Recommendations of the **Industry** Risk Informed Steering
Committee Working Group on PRA Technical Adequacy

March 2015

Comment [NRC -Supp1]: This document provides NRC SUPPLEMENTAL Feedback to the March 2015 version of the Industry whitepaper (ML15086A063).

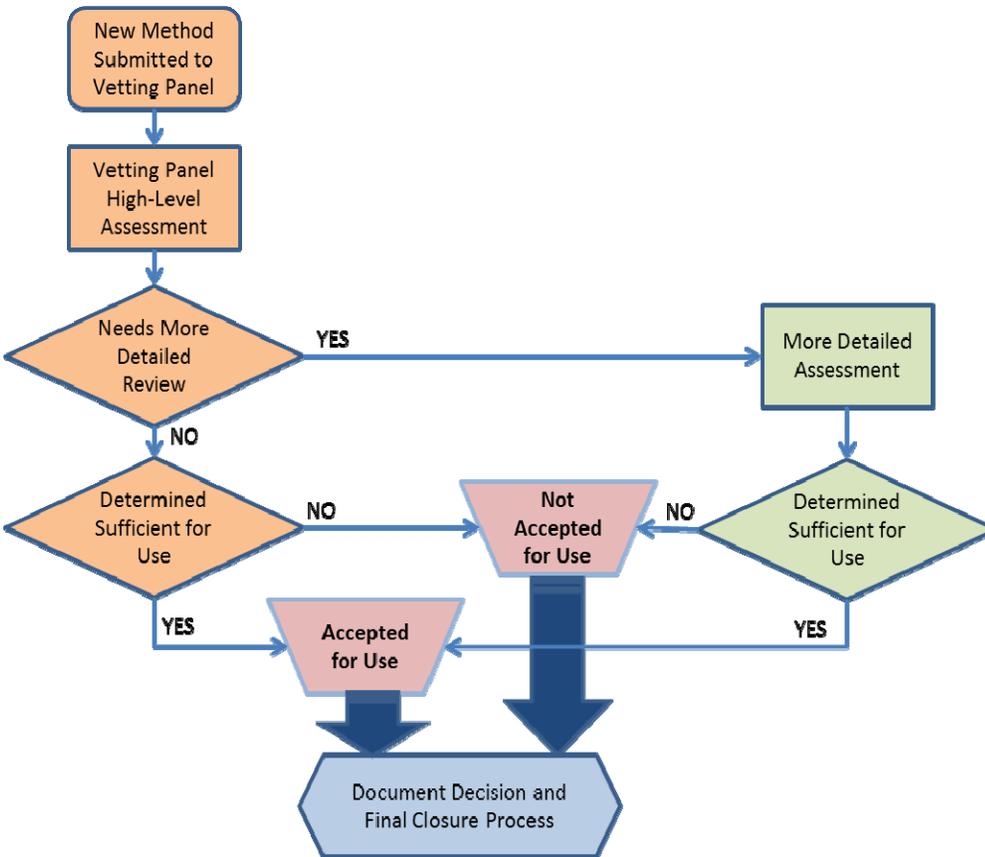
Comment [NRC16]: There may be cases where NRC may need to take a larger role (particularly for process options 4 and 5). Note that there are various levels of scientific peer review and that, as a practical matter, the criteria for publication don't necessarily match those for regulatory acceptance.

Comment [NRC-Supp17]: Process Option 6 is added to make the example clear that Groups B-F can always go to a full methods panel if the Vetting Panel determines that is the appropriate path, especially where acceptance is considered implicit. A similar change needs to be incorporated into the industry flow diagram.

Suggest discussing on 3/30
As discussed at the public meeting on 3/30, one of the points of this comment was to note that the term “peer review” may have different meanings in different circles (e.g., academia).
